High Road West

Whitehall Mews (Plot A)

Comparison between Planning Submission (October 2021) and Current Proposal
July 2022

Revisions	
Rev	C
Date	2022-10-03
Notes	Non Material Amendment Final Submission

Ground floor plan

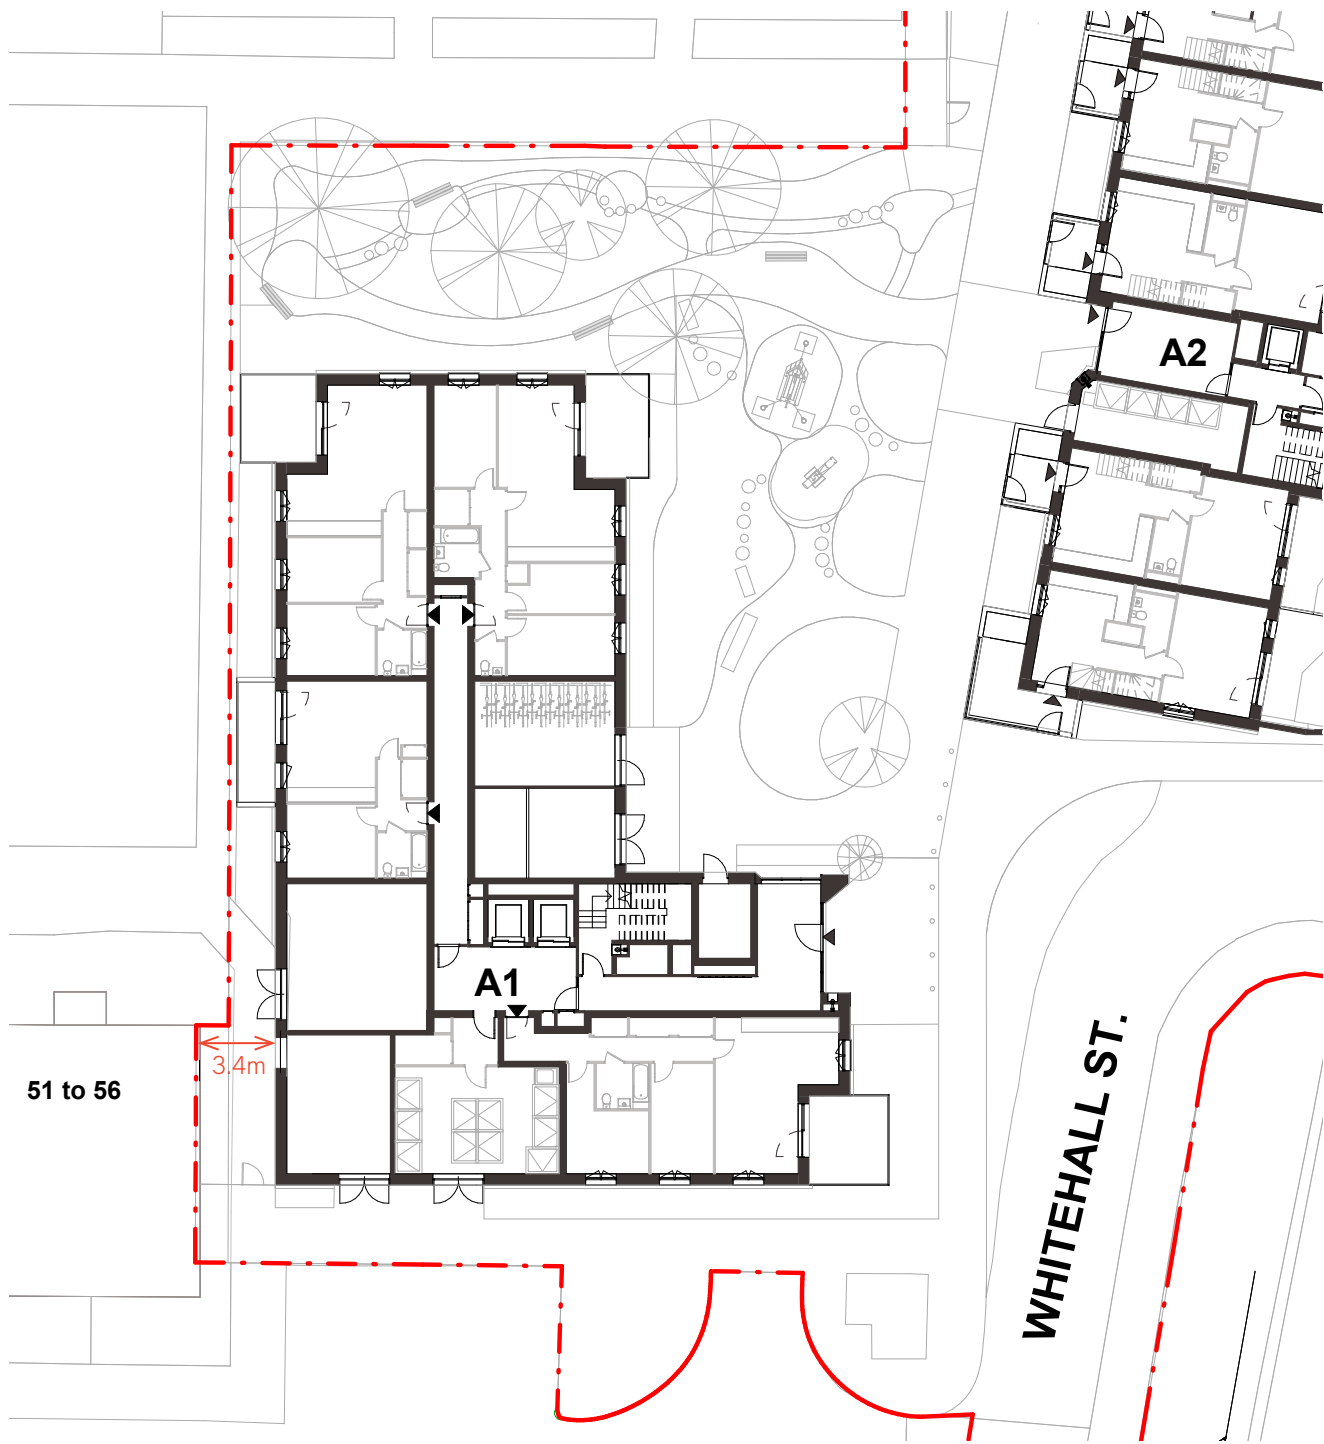
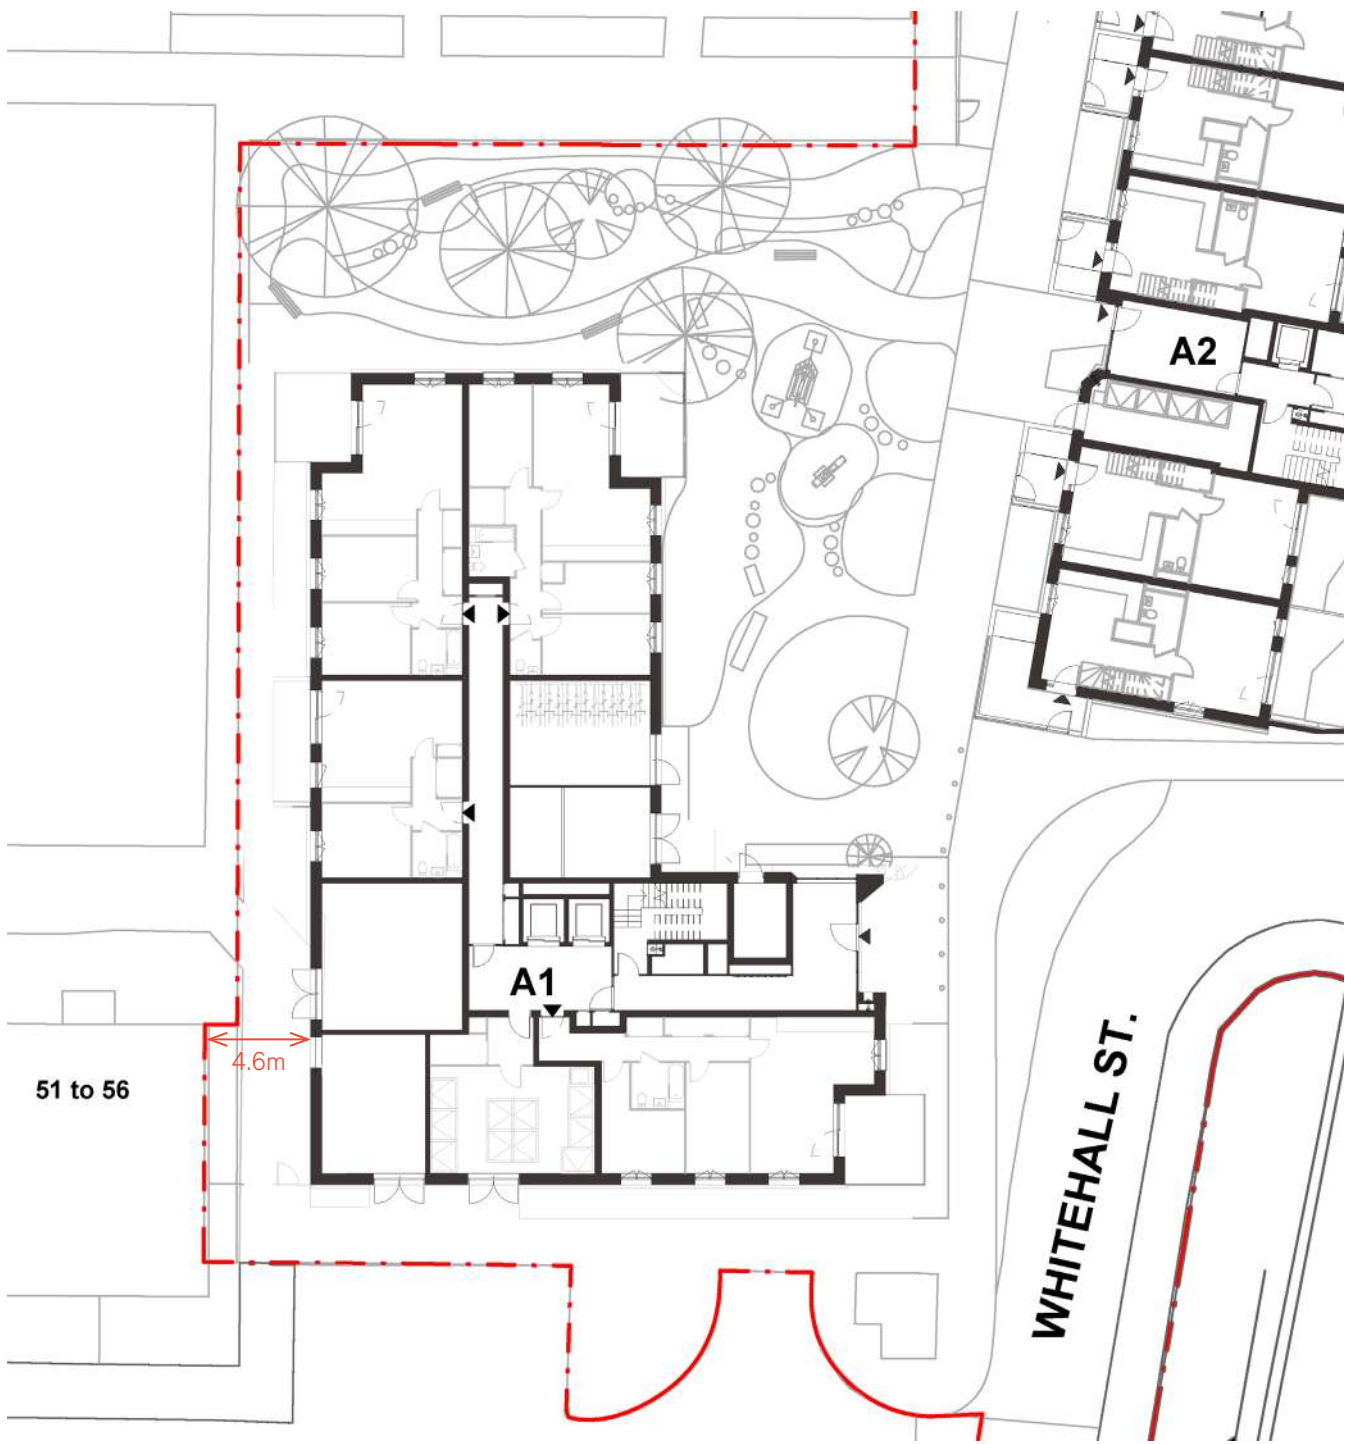
3.1 Realignment of footprint

As a result of design development and alignment with detailed survey information, the footprint of building A1 has been shifted to the east by approximately 1.2m. The massing of building A1 remains unchanged.

The updated position will increase the separation between building A1 and 51-56 Tenterden Road properties from 3.4m to 4.6m, reducing disruption and facilitating greater privacy between windows of block A1 and Tenterden Road properties. Minor improvements to daylighting in the existing and proposed properties is also expected.

3.2 Layout changes

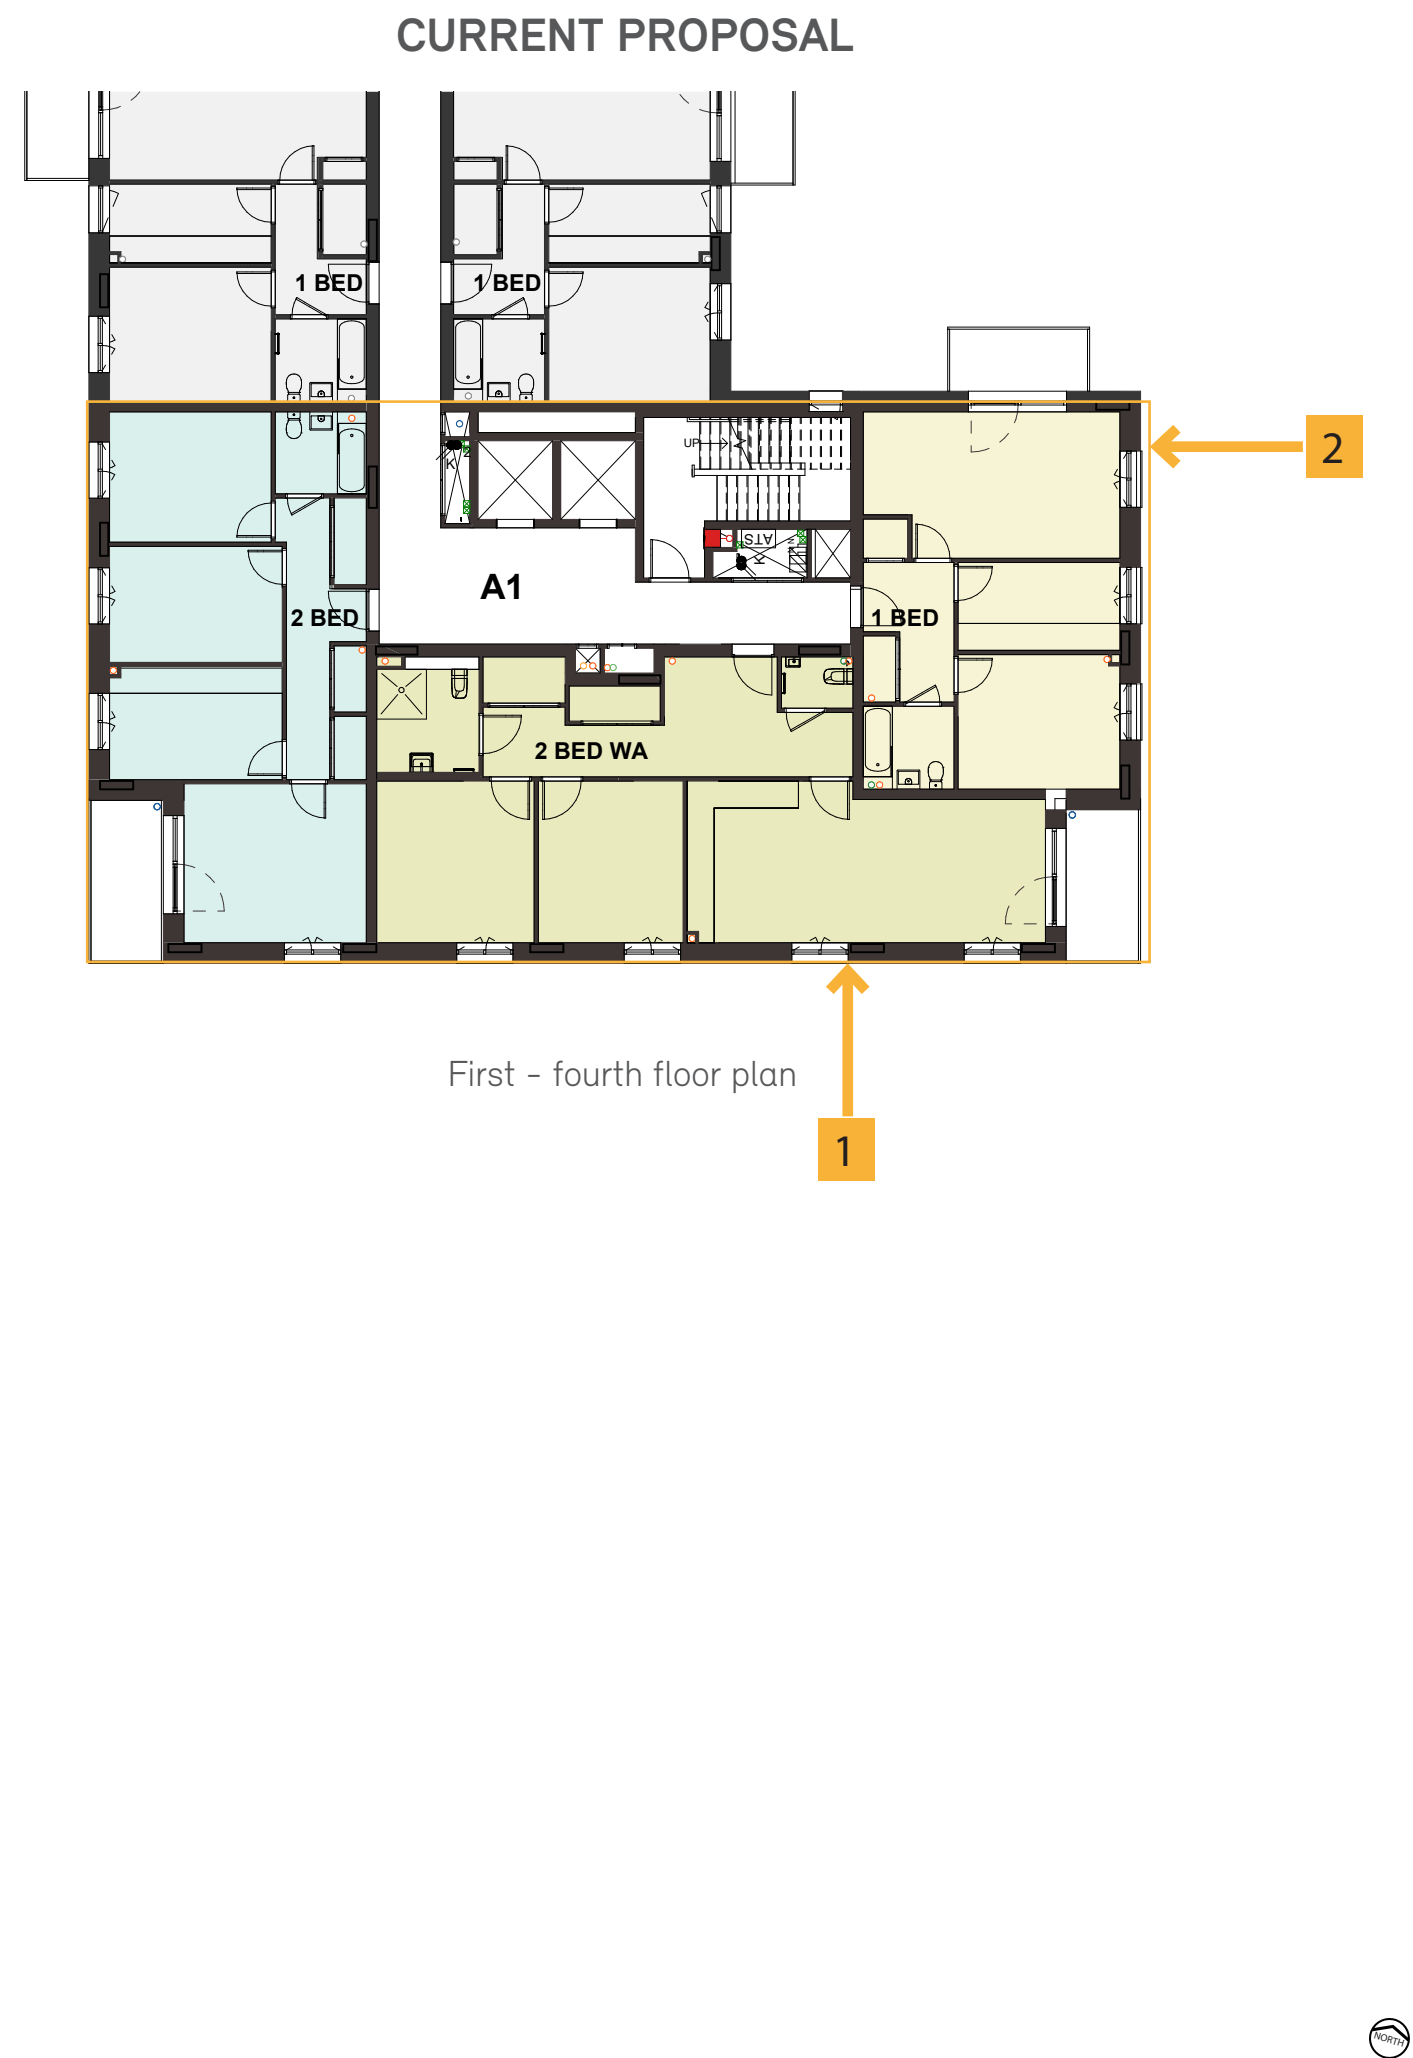
- 1. The 2B3P wheelchair home has been increased to a 2B4P dual aspect wheelchair home, with east facing corner balcony
- 2. The 2B4P home facing east has been reduced to a dual aspect 1B2P home, with a balcony facing onto Whitehall Mews
- 3. Top floor layout has been removed. Southern end of Building A1 stacks from first to fourth floor

Internal layout reconfigurations within Building A1 have been implemented to align with updated requirements of LBH’s Regeneration and Housing Teams requirements, and the emerging Love Lane Estate’s needs assessments. This change has increased the number of dual aspect homes across the plot by 6% (74% dual aspect), and all homes with more than 1 bedroom are dual aspect.

There are 4no. 2B4P Category 3 accessible wheelchair homes on Plot A, totalling 6.6% (previously 8%). It was agreed with the LBH Regeneration and Housing Teams that this is acceptable as it meets the current needs of the Love Lane residents, and that the shortfall of wheelchair homes in this plot can be provided in future phases of the masterplan.

3.3 Elevation changes

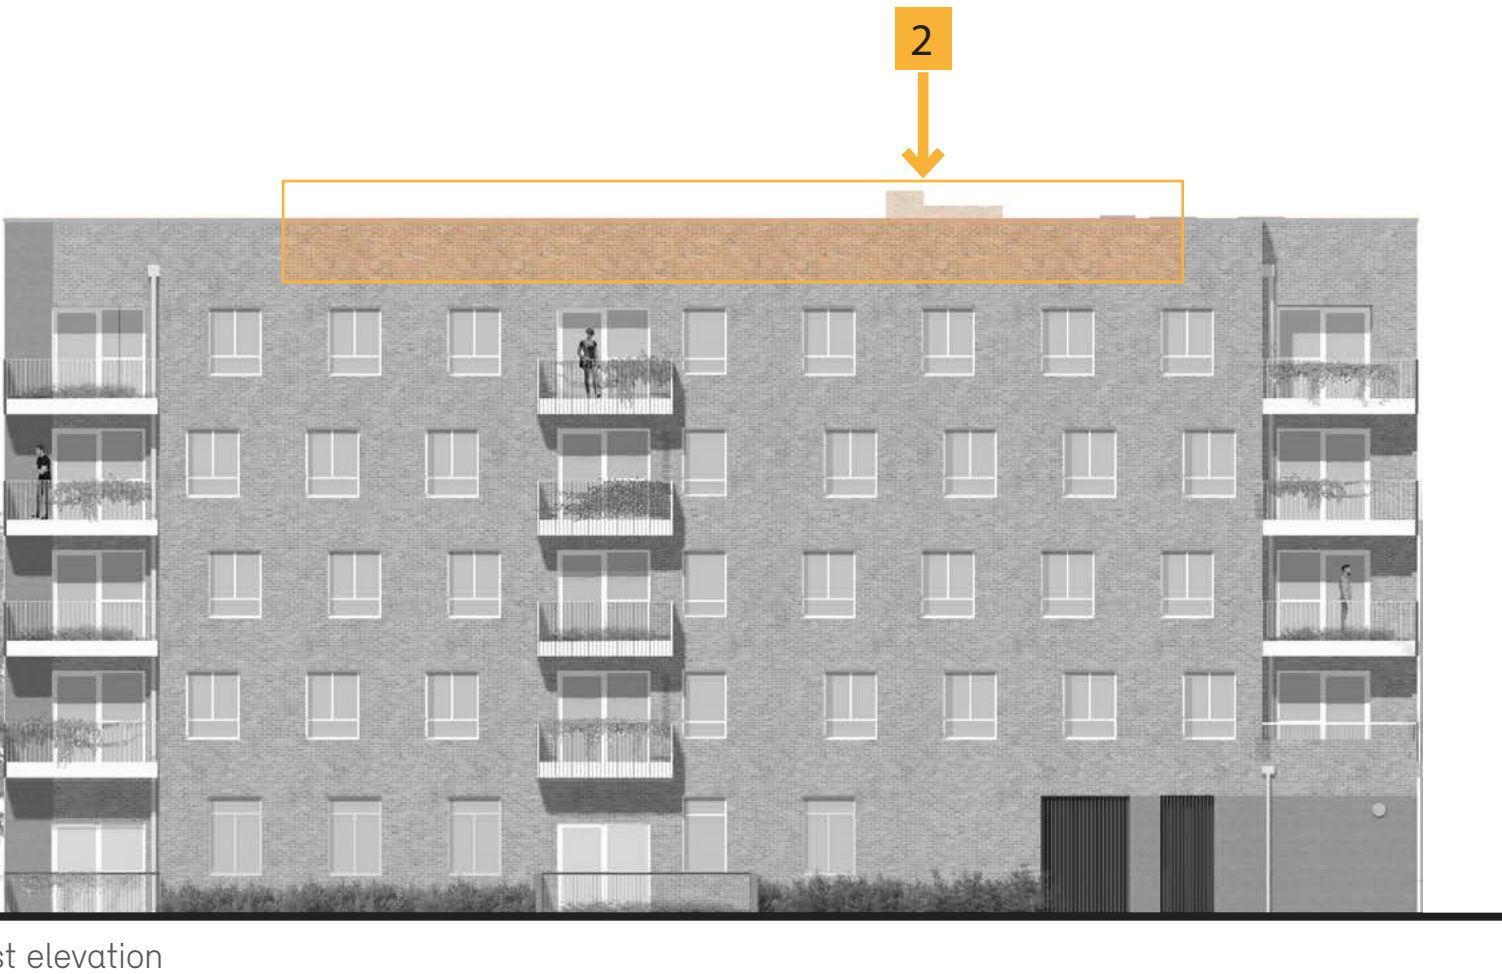
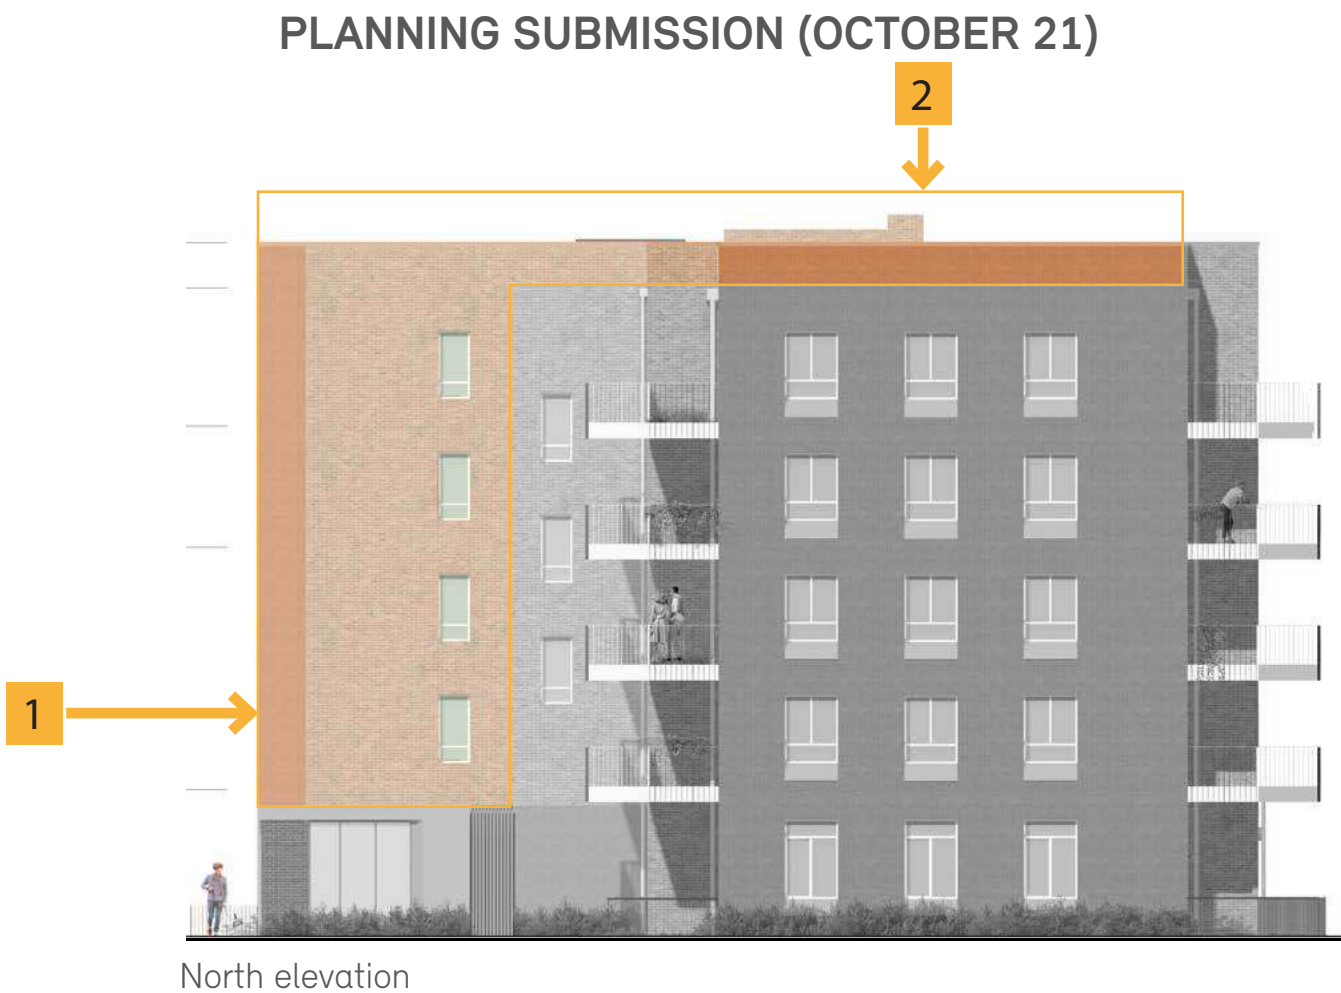
- 1. Minor elevation changes to South and North elevations, in response to the layout changes to the south of Building A1.
- 2. Minor changes to East elevation to include balconies.
- 3. Plant on roof.

South elevation

This elevation previously had 3 projecting balconies, which have now been relocated due to the changes to the internal layouts. The 2B4P Cat 3 home now has a corner balcony to the East of this elevation, so the south projecting elevations are not needed. The principle of the original design has been developed with the windows arrangement, playfully staggered to help create visual interest to the elevation.

East elevation

This elevation now has 4 additional projecting balconies due to the changes to the internal layouts. 4no. 1B2Ps are stacked above the main entrance to Building A1. The balconies have been located so that they

are overlooking the Whitehall Mews garden.
